DWG NAME	F06-CONVERTER-BOARD
----------	---------------------

2					
		1	TBD				
		ITEM	PART NO.		DESCRIPTION		
		Quanta Computer Inc.			MODEL	F06	
RANGE	TOLERANCE	NAME	NEW-CONVENTOR-BOARD			APPROVED	K.P.
0-10	±0.10	TOL. ±	1 PLC	2 PLC	3 PLC	UNIT	mm
10-50	±0.15	MATERIAL	SEE NOTES			SCALE	1:1
50-100	±0.20	FINISH	SEE NOTES			DATE	22-April-15
100-	±0.25		The 3D Projection			DWG NO.	TBD

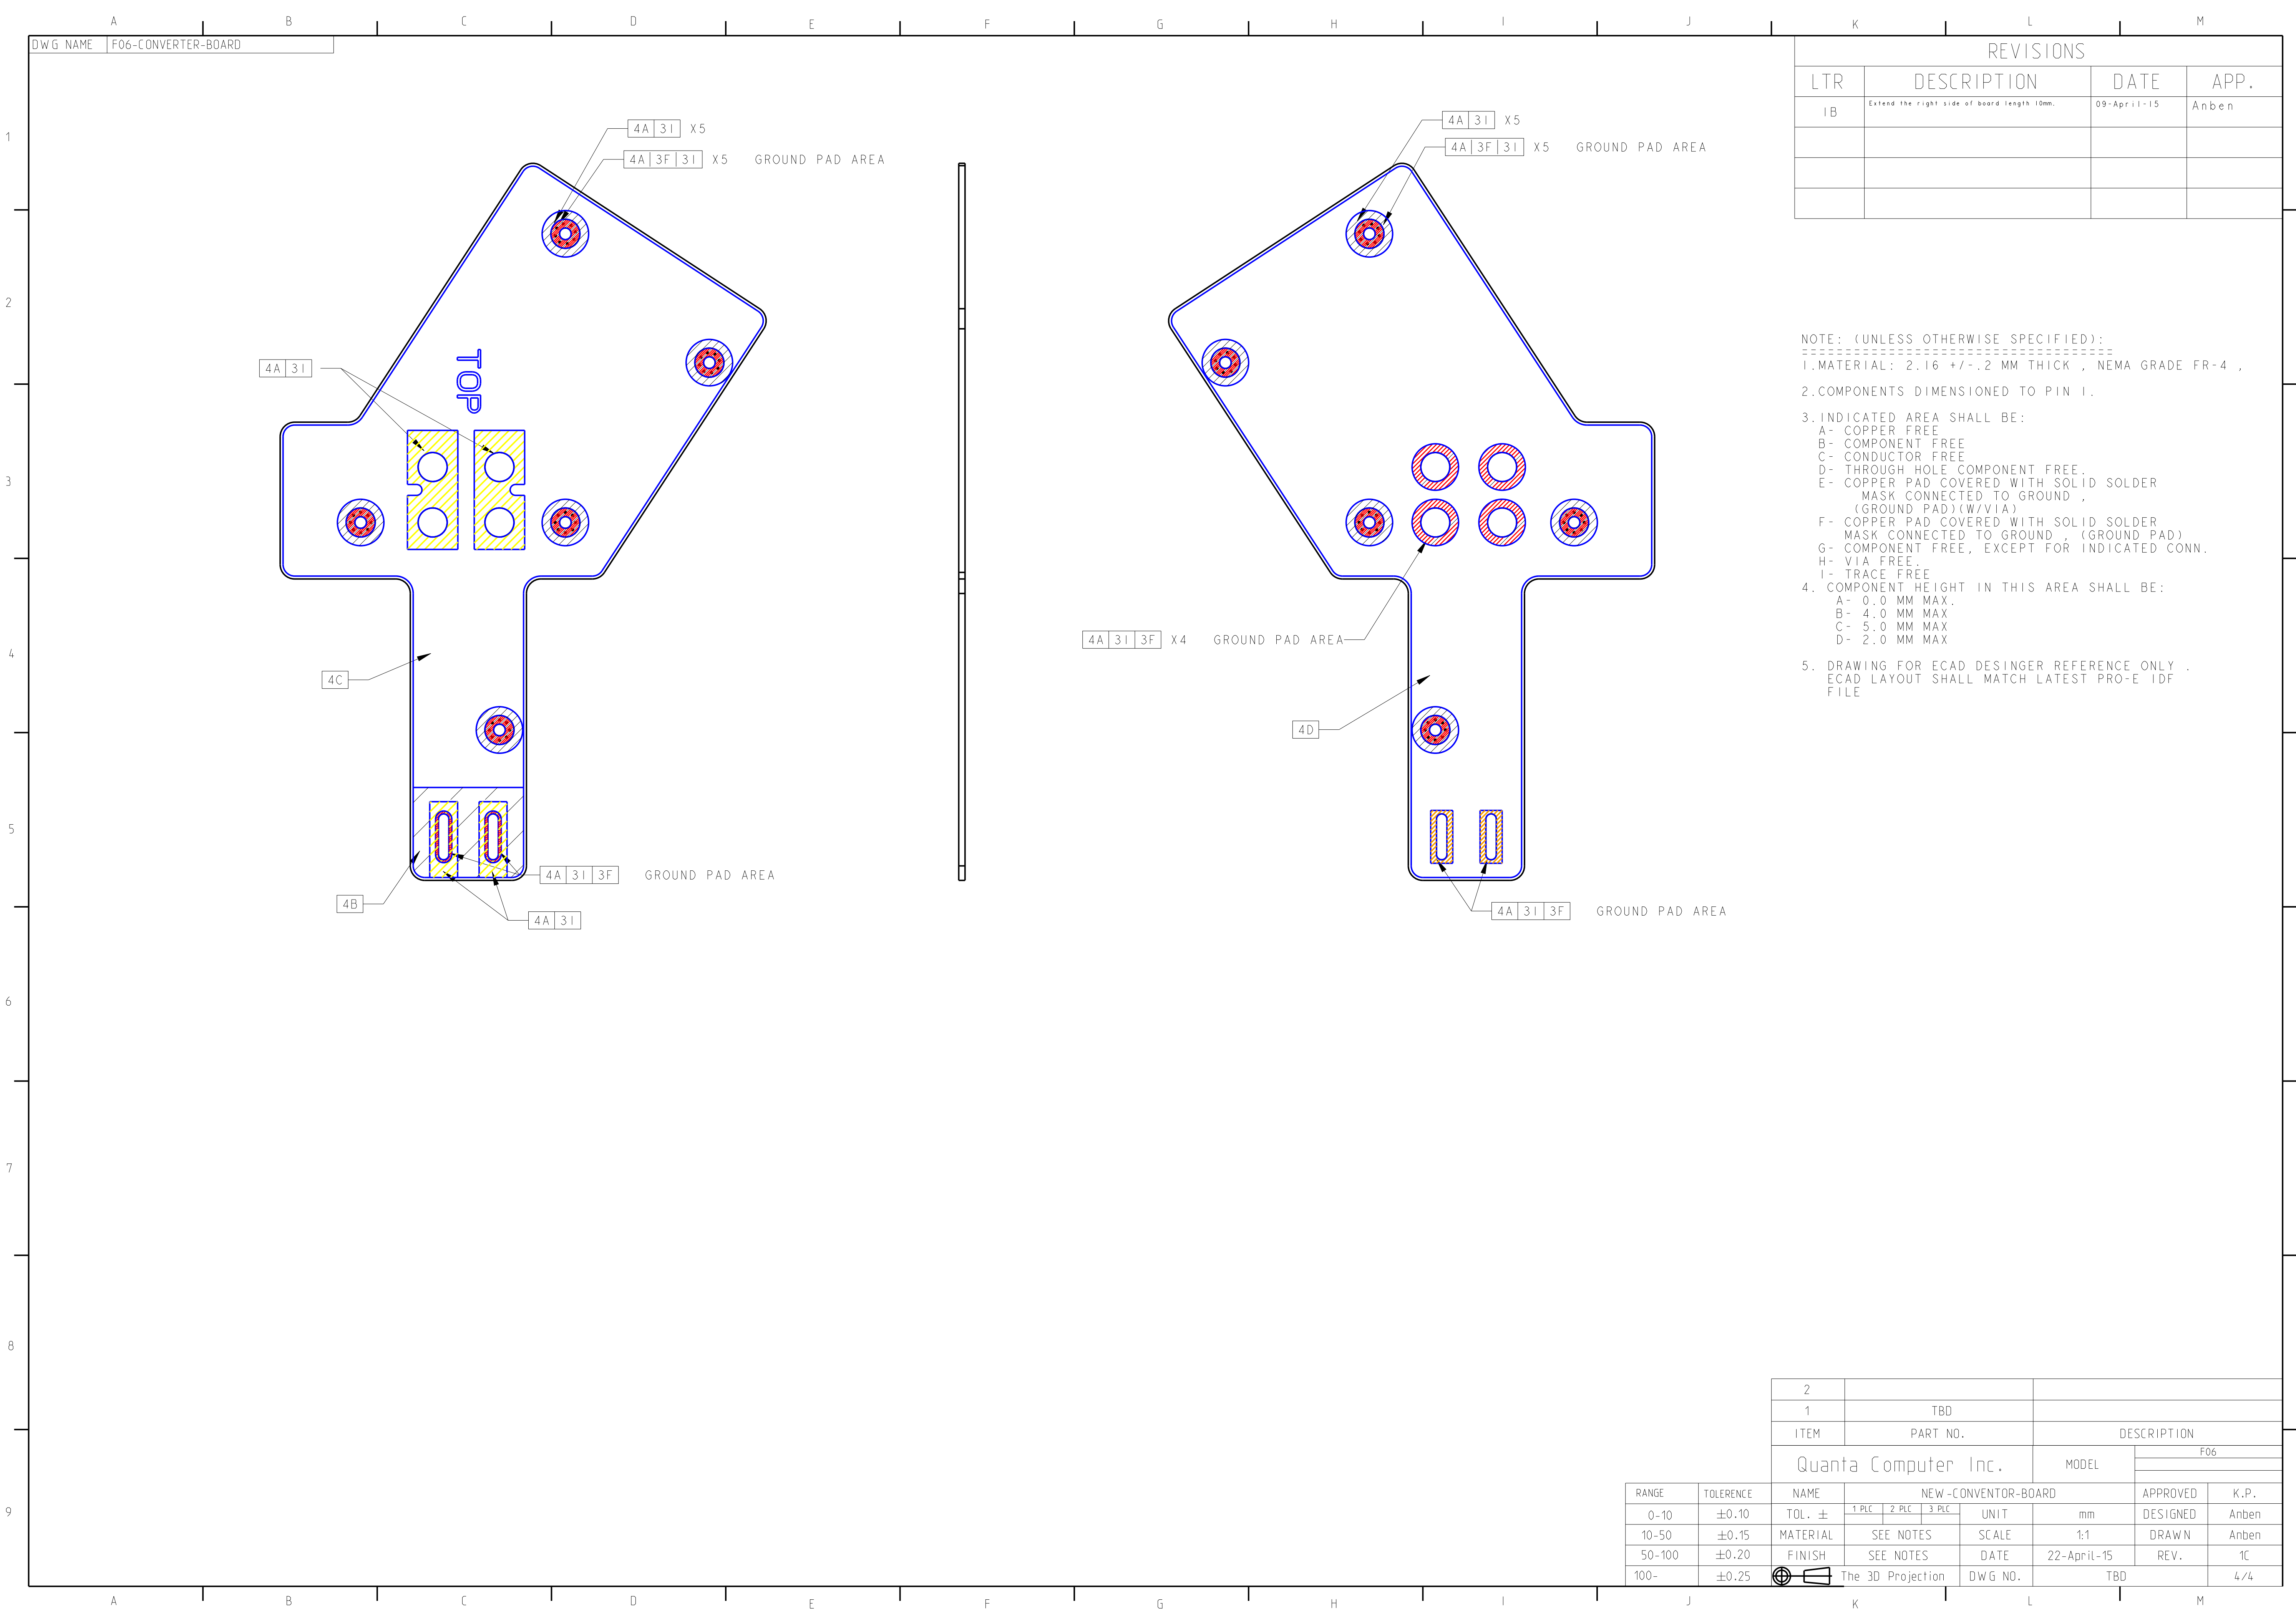
REVISIONS			
LTR	DESCRIPTION	DATE	APP.
1B	Extend the right side of board length 10mm.	09-April-15	Anben
